June 29, 2011
NRC-11-0018

Subject: Enrico Fermi Atomic Power Plant Unit 1
Fermi 1 Groundwater Site Conceptual Model

In response to questions from the NRC staff's review of the LTP and "Report on Groundwater Characterization," Detroit Edison is submitting a new report on groundwater at the EF1 site, entitled "Site Conceptual Model" documenting the results of an assessment performed by Conestoga-Rovers & Associates. Revision 1 of the "Site Conceptual Model" is the first version of the report being submitted to the NRC.

Attachment 2 -Responses to NRC Groundwater Questions

figure 2
AERIAL PHOTOGRAPH SITE MAP
SITE CONCEPTUAL MODEL
DTE FERM 1
Newport, Michigan

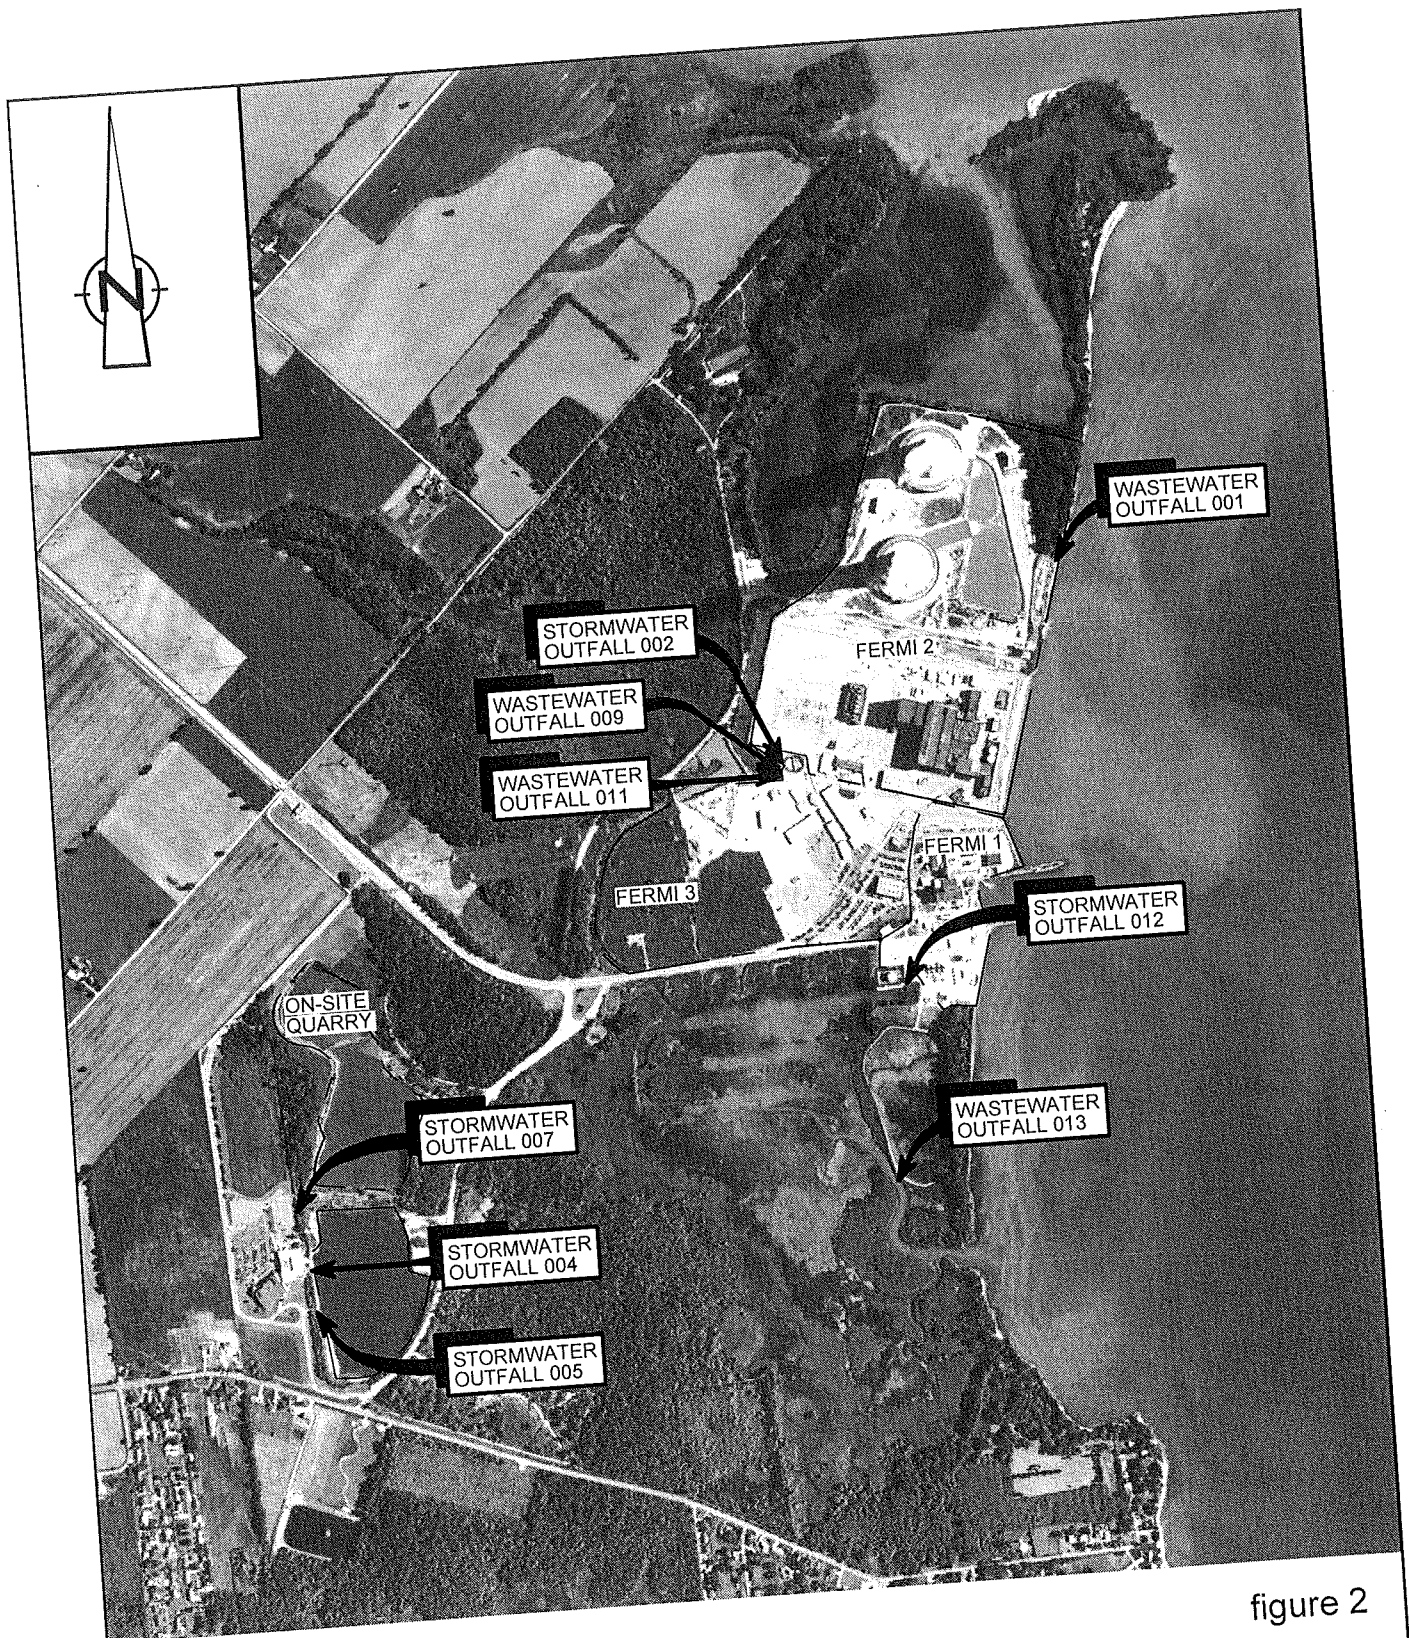
Question 4: The report states that Golder installed 16 monitoring wells at 11 locations, but figure 2 shows 15 monitoring wells at 10 locations. Please include monitoring well EFT-1I onto figure 2.

Response to Question 4: Figure 3 of Attachment 1, "Site Conceptual Model, Revision 1", shows the location of EFT1S, 1I and 1D, which are located adjacent to each other.
